Models 281/288

New oil pump

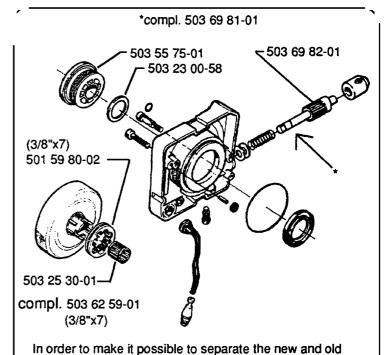
In order to improve the sealing against dirt, a new worm gear and a new pump piston is introduced. This means a labyrinth sealing instead of a V-ring. The same solution is available on the model 394.

NOTE! The new worm gear and the new pump piston do not fit old saws/oil pump housing.

> When purchasing a new oil pump compl, a new worm gear must be ordered separately.

Clutch drum ref. no. 503 62 59-01, should be used to the new oil pump.

piston, we have marked the new with a turned groove.
